## DEVELOPMENT REVIEW COMMITTEE (DRC) COMMENT REPORT

**PROJECT NAME:** Hilton Marina Hotel

**CASE NUMBER:** R19031

**REQUEST:** Site Plan Level III Review: Waterway Use, Modification of Required Yard and Parking Reduction for 52,025 Square Foot Marina Hotel Expansion

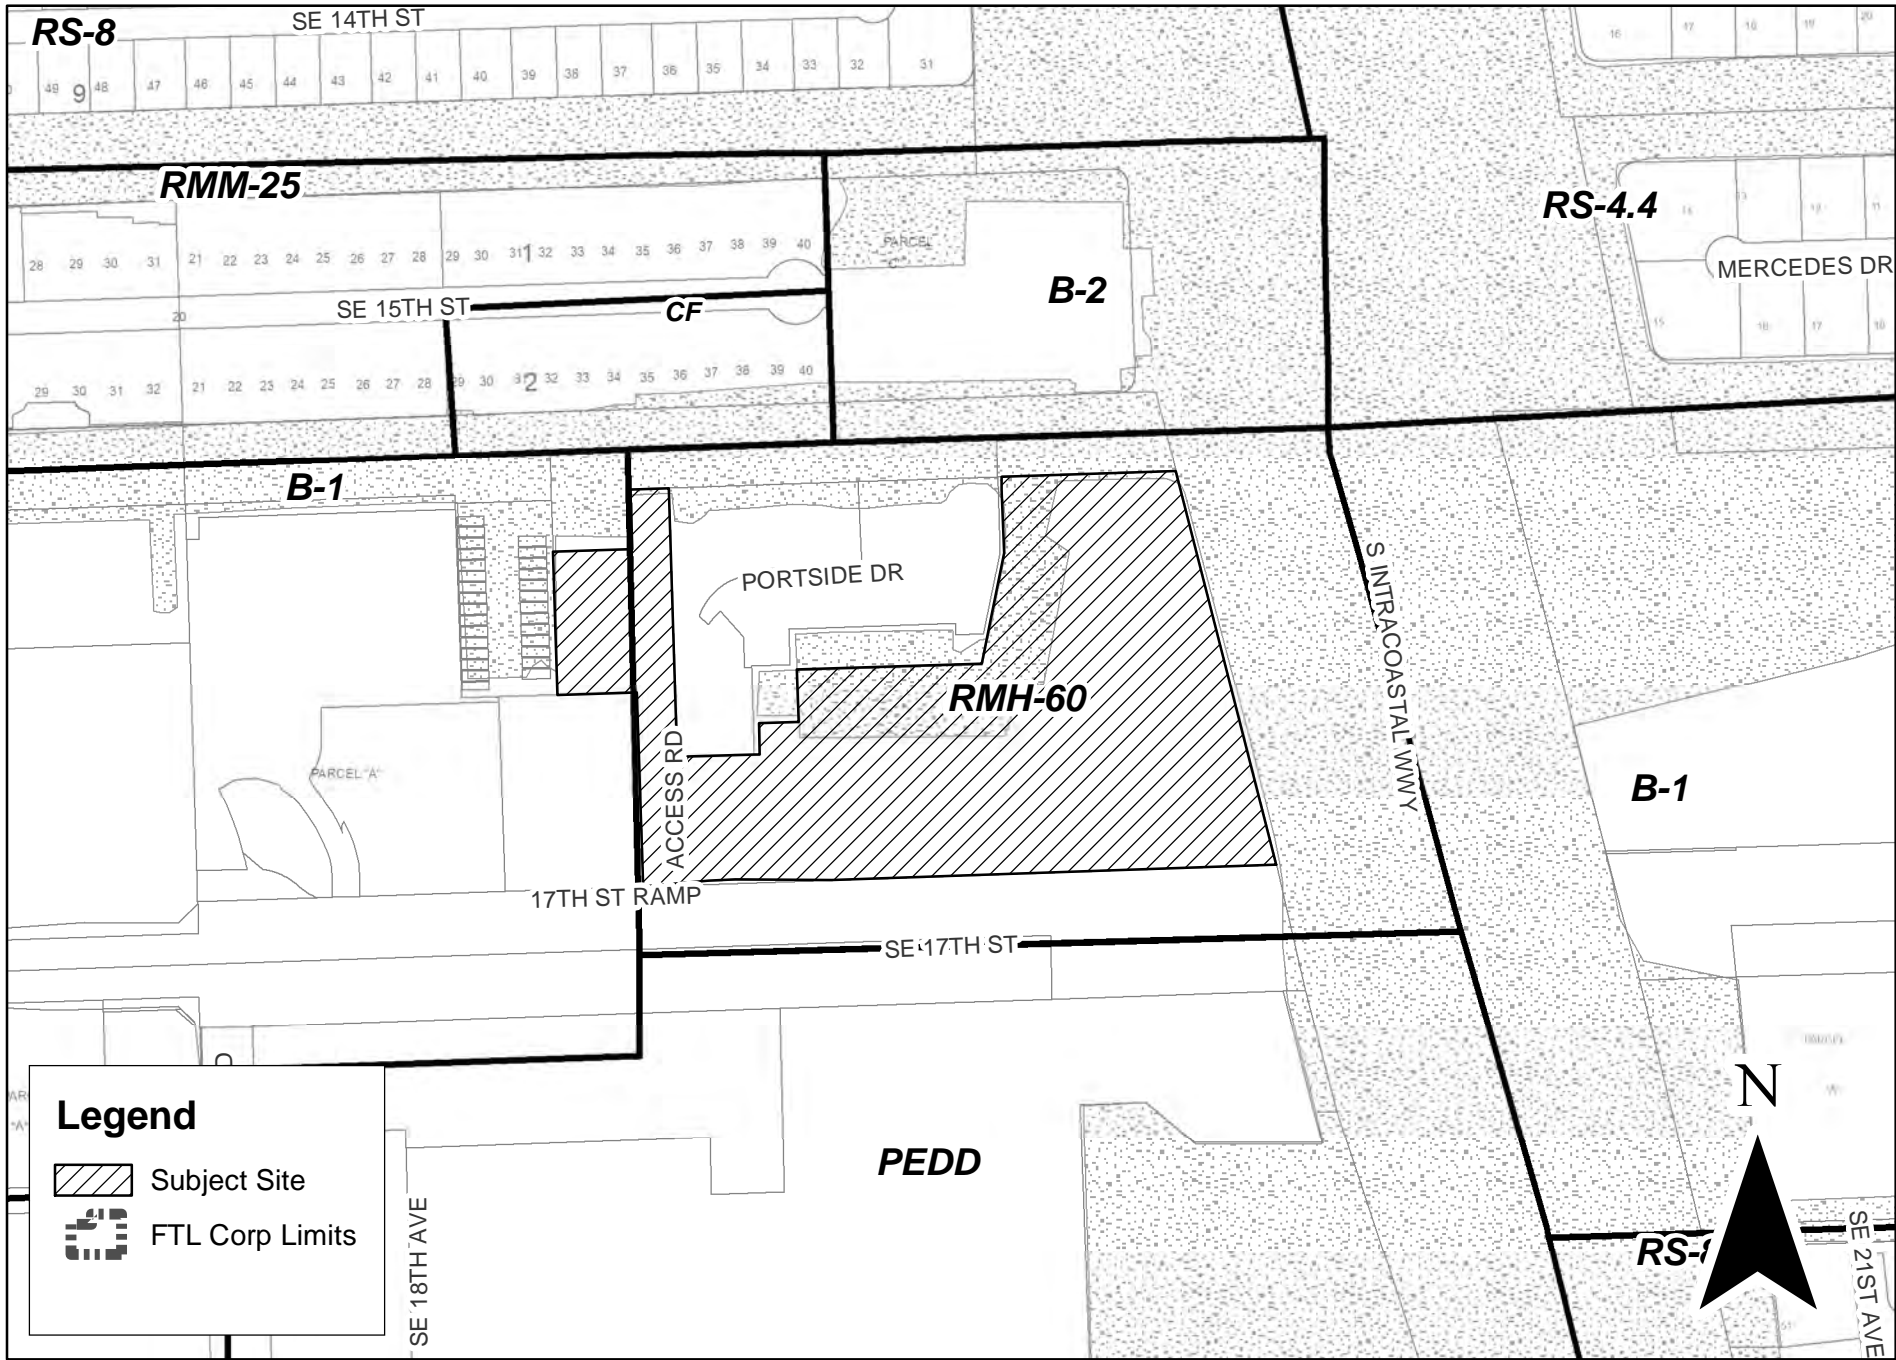
18. Is there any additional signage proposed? If so, pursuant to ULDR, Section 47-22.4.C.8 provide a master sign plan detailing the following:
  - a. Location and orientation of all proposed signage;
  - b. Dimensions of each proposed sign (height, width, depth, etc.);
  - c. Proposed sign copy; and,
  - d. Proposed color and materialsPlease note any proposed signs will require a separate permit application.
